1. Type of Well / <input checked="" type="checkbox"/> Oil Well <input type="checkbox"/> Gas Well <input type="checkbox"/> Other		8. Well Name and No. THOR 21 FED COM 704H ✓
2. Name of Operator EOG RESOURCES, INC. ✓		9. API Well No. 30-025-42816 ✓
3a. Address P.O. BOX 2267 MIDLAND, TX 79702		10. Field and Pool, or Exploratory WC-025 G-09 S263327G
3b. Phone No. (include area code) Ph: 432-686-3689		
4. Location of Well (Footage, Sec., T., R., M., or Survey Description) Sec 21 T26S R33E SWSE 170FSL 1670FEL ✓		11. County or Parish, and State LEA COUNTY, NM

EOG Resources requests an amendment to our approved APD for this well to reflect a change in casing design.

Sundry NOI - Casing Change - Thor 21 Fed Com 703H & 704H

**Thor 21 Fed Com 704H
30-025-42816
EOG Resources, Inc
Surface Location: Sec. 21, T. 26S, R. 33E
Conditions of Approval**

Thor 21 Fed Com #703H

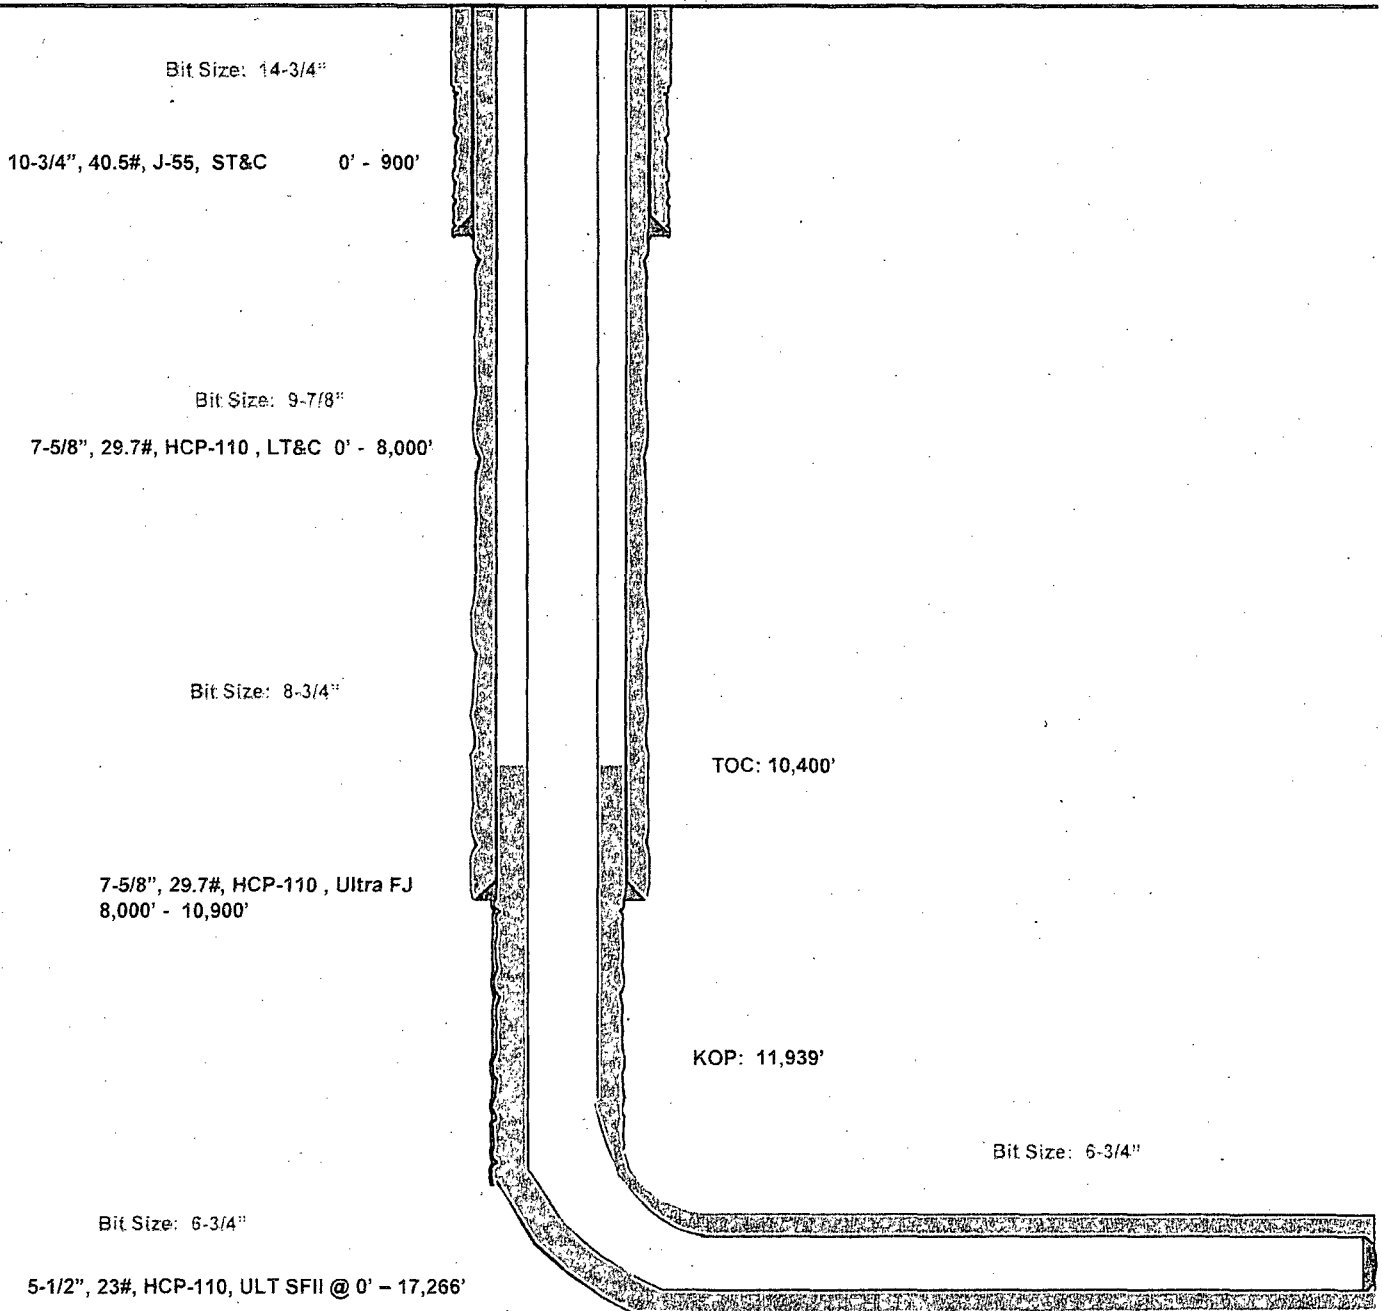
I am reviewing on the 703H, I was doing my calculations and I noticed a 10M BOP & BOPE system is actually required below the intermediate casing. As of now the the Drilling Program only proposes a 5M system.

$12,520 \text{ [Max TVD in Sundry]} * (12.00 \text{ [Max MW at that Depth in Sundry]} / 19.25 - 0.22 \text{ [Assumed Gas Gradient]}) = 5045.543 > 5000$. Therefore BOP & BOPE needs to be rated, as well as tested, to a 10M System.

Because of this, I am requesting EOG to review the BOP and BOPE for this notification to address this issue.

We will resubmit and change the anticipated mud weight range to 10.0 to 11.5 ppg. Normally we drill these laterals with mud weights ranging from 9.5 to 11.5 ppg. Almost always we get it done with 10.5 ppg or less.

So the 11.5 ppg maximum anticipated MW keeps us below the 5000 psi shut in surface pressure scenario.

I'm very comfortable with this. All of our rigs are equipped with 10,000 psi BOPs and chokes. The only piece of equipment that is not rated for 10,000 psi is the annular BOP.
